GGG-T-0030 (GSA-FSS)
AMENDMENT-1
February 1, 1994

AMENDMENT

INTERIM FEDERAL SPECIFICATION

TACKER, STABLE (COMPRESSION TYPE, MANUALLY OPERATED FOR ROUND CROWNED STAPLES) AND STAPLE, TACKER (ROUND CROWNED)

Figure 1.- Type I staples.

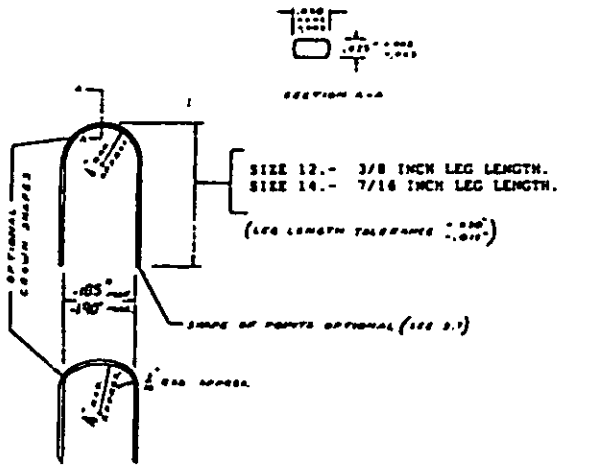
Page 4, delete "Figure 1" and substitute the following:
